**POLK COUNTY, A POLITICAL SUBDIVISION OF THE STATE OF FLORIDA**  
**ADDENDUM # 4**

**BID # 26-372, Saddle Creek New Office and Maintenance Buildings**

### Addendum # 4

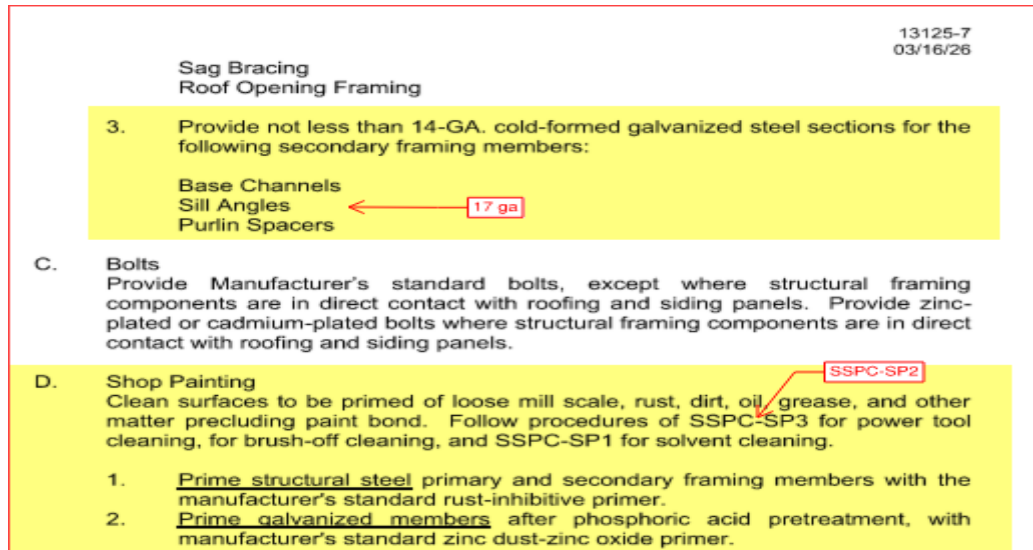
**Question 1:** Butler's standard is different than the ones listed in the specifications. The building will meet code. I have included an example:

Can we submit with Butler's standards as long as we meet code?

**Answer:** 17 gage is acceptable as long as the building meets all wind loading requirements shown on the structural drawing for Risk Category II. SSPC-SP2 is acceptable.

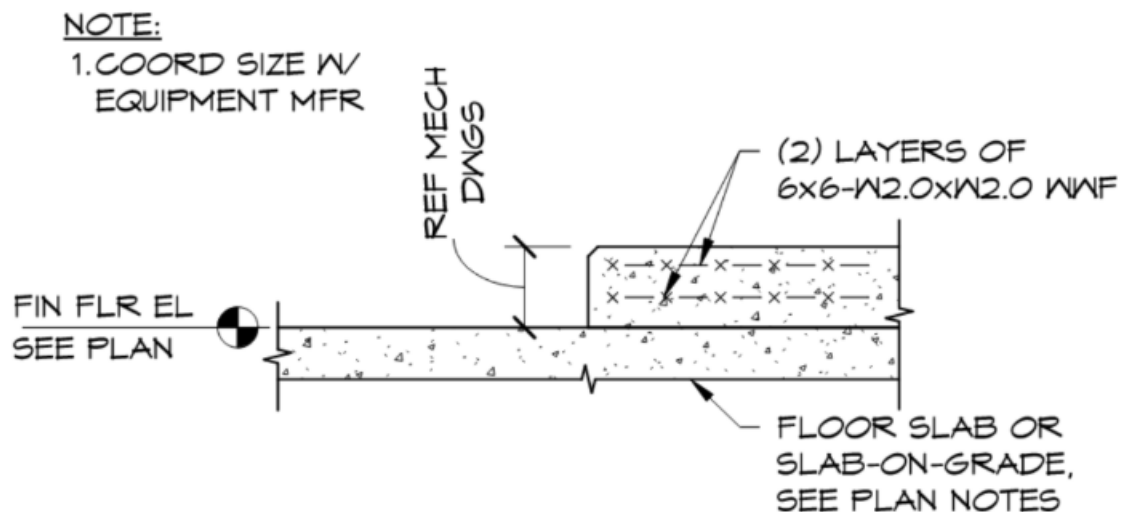
**Question 37:** All metal lockers noted by 1028 are set on 6" housekeeping pads, and all HVAC air handlers are set on 4" housekeeping pads noted by 1501. There are no details shown for either of these pads. Please provide a detail/reinforcing for the housekeeping pad.

**Answer 37:**
